ADDENDUM NUMBER TWO

City of Lyndon
Police Headquarters
LYN.2301

This addendum shall form a part of the Contract Documents and modifies the original Bidding Documents as prepared by LMH Architecture, PLLC dated June 12, 2024 and all previously issued addenda. Acknowledge recipient of this Addendum in the space provided on the Bid Form. Failure to do so may subject Bidder to disqualification.

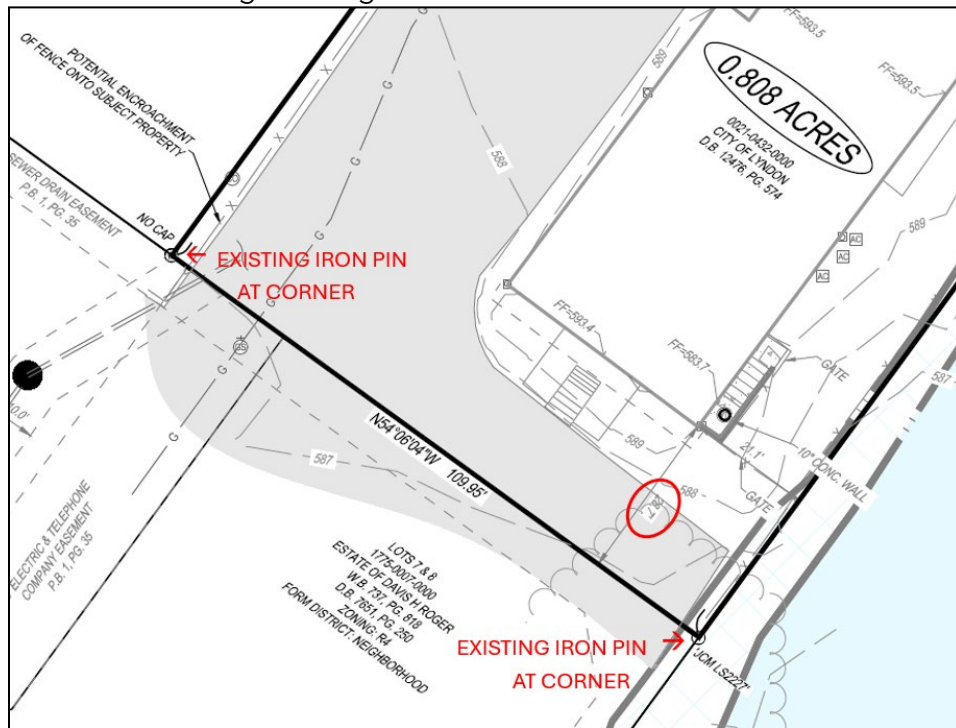
11. Where is the property line on the south end of the property line? This will affect the footage of the new 8'h privacy fence. (See pictures attached in email.)
 - a. The south property line is indicated on sheet C100 Existing Conditions. It is monumented by two property corners. It is approximately 28.7 feet south of the south face of the existing building. See below:

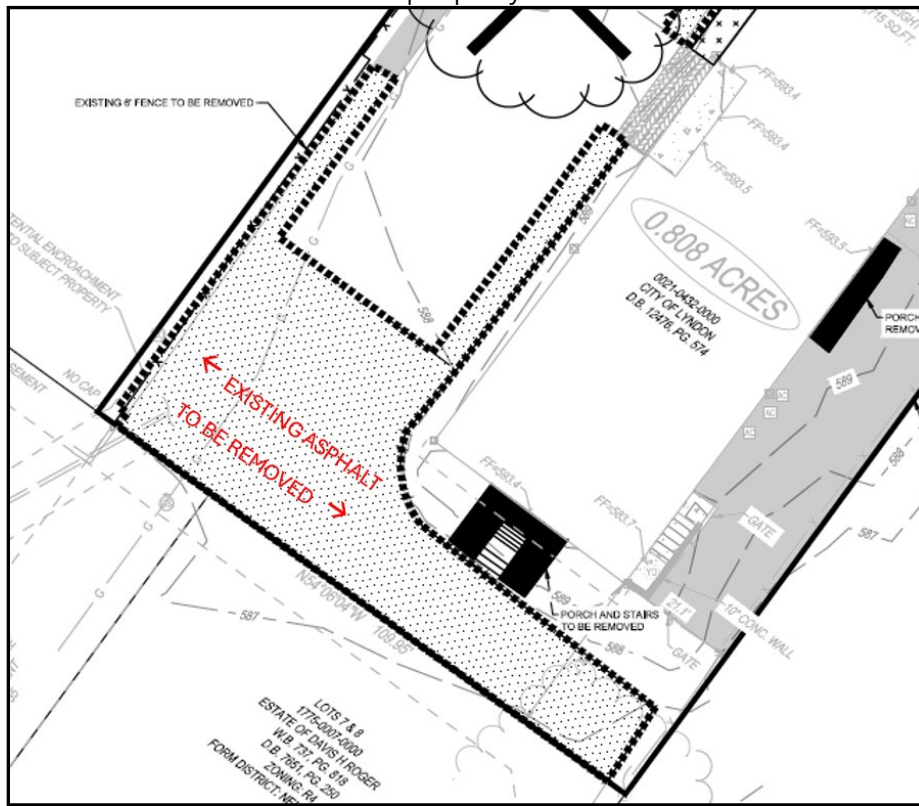
13. Will the asphalt on the south end of the building be removed?

- a. Yes. Refer to sheet C200 Demolition Plan for limits of asphalt to be removed. Asphalt is to be removed to the south property line. See below:

Plan View @ Lowest Landing

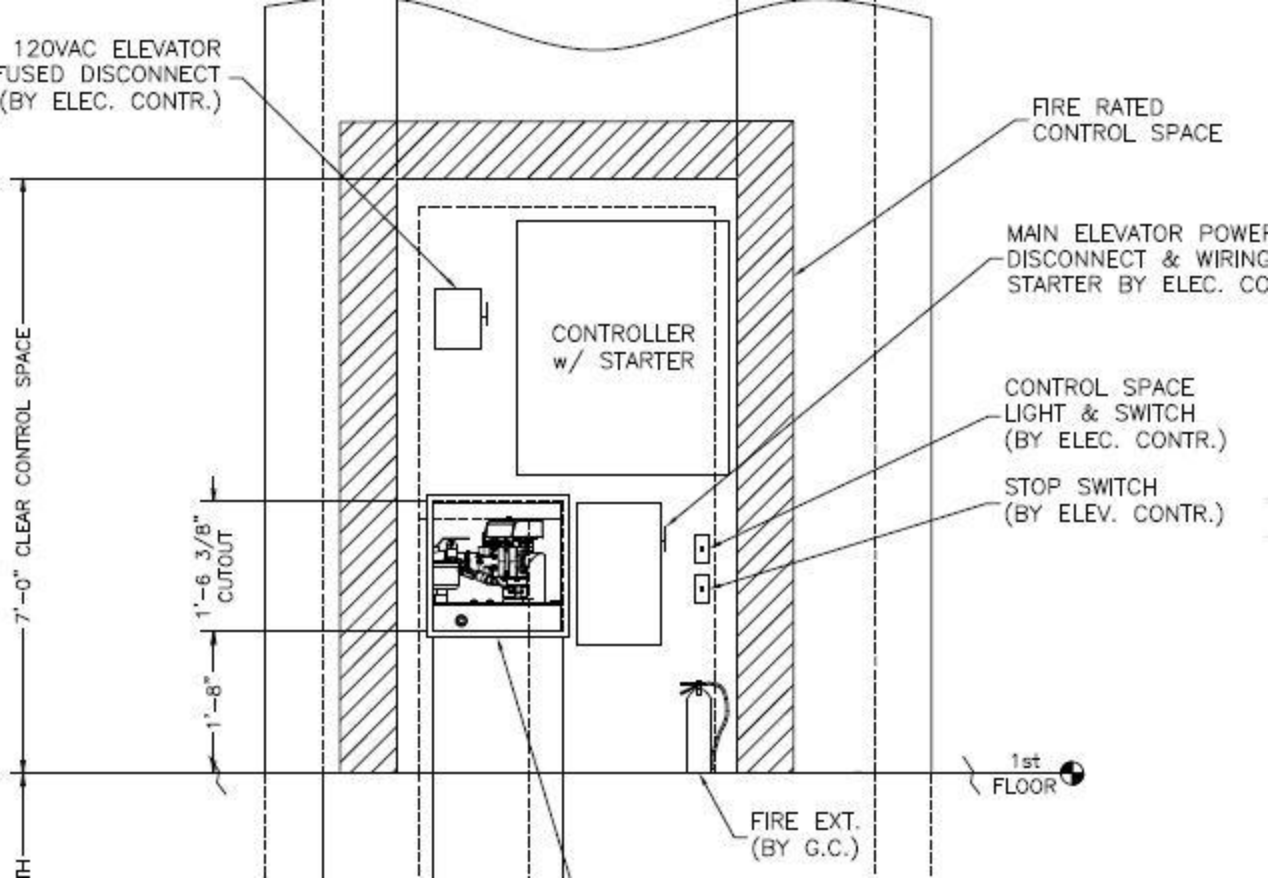
7. Attached are mock hoist way drawings. This hydraulic pump is on the inside of the shaft. It is still a machine room less elevator. There is a 1'-6" deep control closet on the side of the shaft. However, we CAN eliminate the closet by having the 3'-6" man door recessed in the shaft wall. We would install a steel shroud, bolted to the inside of the shaft, that is used to mount our controller, main line and cab light disconnects to. The pump unit is directly at your feet when you open the door to allow access to the control valve in a safe and responsible manner. See the snip image attached also, to show how everything is mounted to the shroud. This is very similar to the OTIS HydroFit design.

- a. This is an acceptable substitution as long as the performance specifications in section 14 24 00 are still met. Contractor to coordinate associated work with all trades.

Code Criteria - Legends and Abbreviations

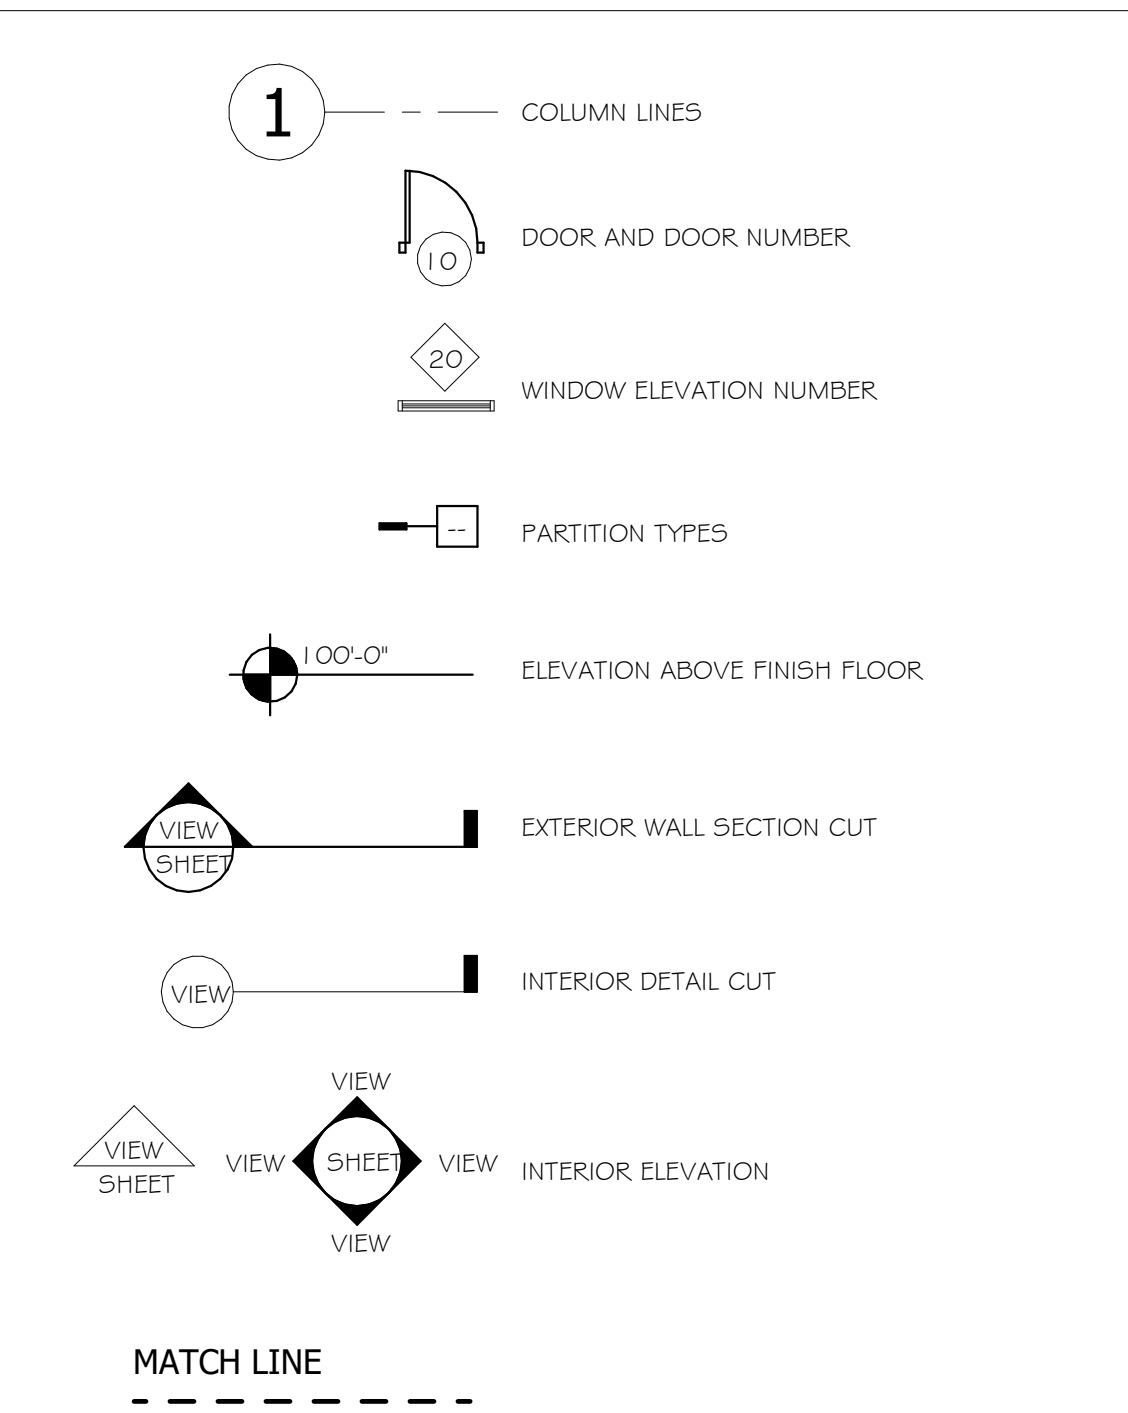
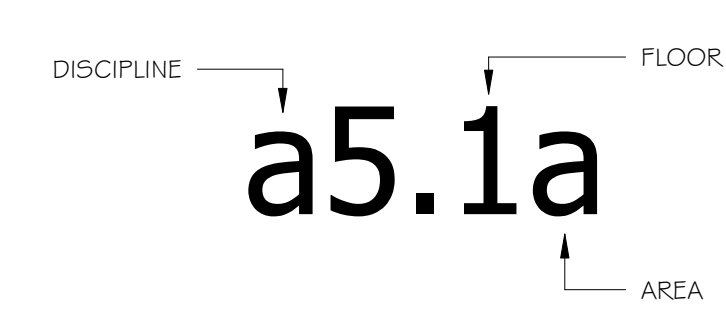
10. Please clarify how Alternate #1 applies to the Mechanical scope. Alt #1 to include Mechanical 006, Armory 014, and Mechanical 021. Should MC include equipment in Mechanical rooms only as well as SA duct main to Armory 014?

- a. Refer to Sheet X1 for Alternate 1 description of Mechanical Scope.

ALTERNATE 1:
PROVIDE A LINE-ITEM COST TO ELIMINATE ALL AREAS AND ASSOCIATED WORK IN THE BASEMENT EXCEPT FOR CLOSET 002A, STAIR 003, MECHANICAL 006, ELEVATOR 007, STAIR 012, ARMORY 014, AND MECHANICAL 021.

ALTERNATE 4:
PROVIDE 6" WOODEN PRIVACY FENCE ALONG EAST SIDE OF PROPERTY WHERE CHAINLINK FENCE IS DEMOLISHED.
